MONTGOMERY COUNTY PLANNING DEPARTMENT
THE MARYLAND-NATIONAL CAPITAL PARK AND PLANNING COMMISSION

DATE: **September 25, 2009**

TO: Montgomery County Board of Appeals
VIA: Rose Krasnow, Chief, Development Review Division
Ralph Wilson, Zoning Supervisor, Development Review Division
FROM: Elsabett Tesfaye, Planner Coordinator (301) 495-1301

SUBJECT:
1. **Preliminary Forest Conservation Plan No. S-2710** Day Hill LLC. (Kiddie Academy).
2. **Special Exception S-2710**: Day Hill LLC. (Kiddie Academy) Request for a special exception for a Child Day Care Center for 158 children located on Parcel A, Block C, Bel–Pre Manor Subdivision, Silver Spring.

SPECIAL EXCEPTION SITE PLAN
BEL-PRE MANOR

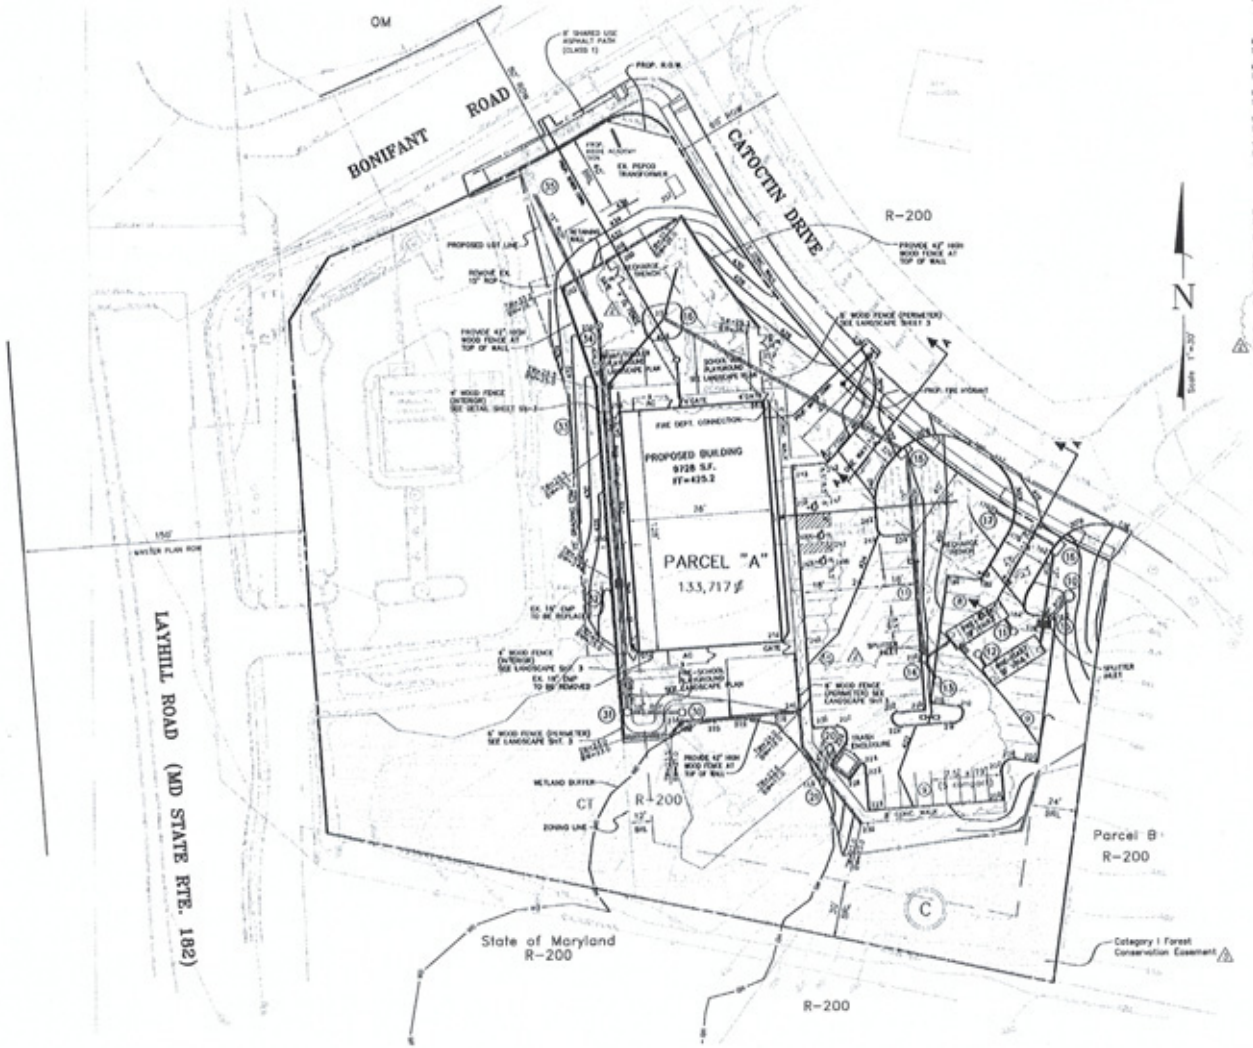
A total of 52 parking spaces are required for the proposed uses on the subject property. The site plan provides a total of 52 parking spaces, including three handicap spaces, one of which is van accessible. Five of the parking spaces are compact spaces. The applicant is requesting that the Planning Board grant a waiver allowing the five compact spaces. A granting of a waiver in this case is not necessary since the Planning Board can allow up to 10 percent of all required spaces pursuant to **Section 59-E-2.2.2** (see page 21 of this report for further discussion).

A special exception site plan is submitted showing the building and other facilities, as required. This review is base on revised special exception site plan with a revision dated August 26, 2009 and submitted to staff on September 9. 2009.

MONUMENT SIGN

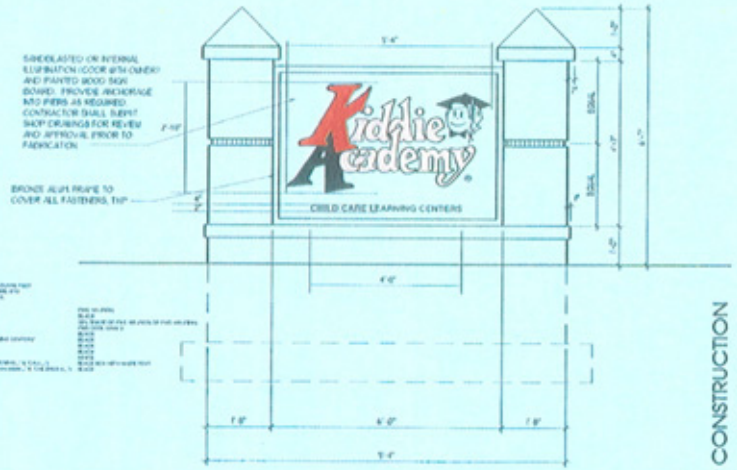
By a letter dated June 19, 2009 to Mrs. Dolores Ustrel of the Beacon Place HOA, the Applicant has agreed to the HOA request for removal of the monument sign. In response to staff's inquiry the applicant's engineer has indicated that the originally proposed sign is now relocated from northeastern portion of the property to the northwestern portion of the property, away from Catoctin Drive. Accordingly, the plans are revised showing the new location. The applicant has provided details of the proposed monument sign which exceeds the allowable size for residentially zoned areas. Details are also provided for the proposed wall, entrance and temporary signs. All signs placed on the property must meet the requirements of Section 59-F-4.2 (a) in terms of number, location and size and Section 59-F-4.1 (e) regarding illumination.
